Bulletin No: WAS082
Date Issued: 2/02/2016
Reference No: Local
Issued by: B.Nguyen

SERVICE BULLETIN WASHING MACHINE

MODEL: ESV80HA

SUBJECT: Replacing the door lock.

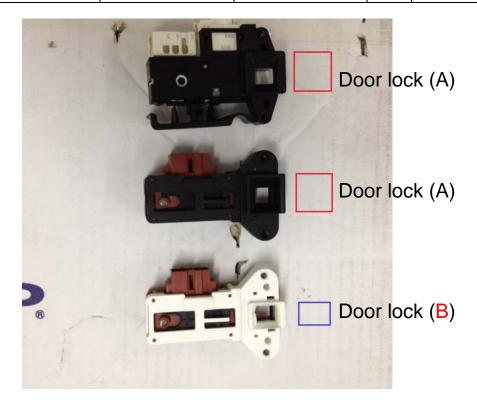
GENERAL: Incompatibility issue may occur if incorrect door lock was ordered for different production

lots. Please refer to the below on how to identify different version and order appropriate

part.

ACTION: If you are servicing above model, please order appropriate door lock type per below chart:
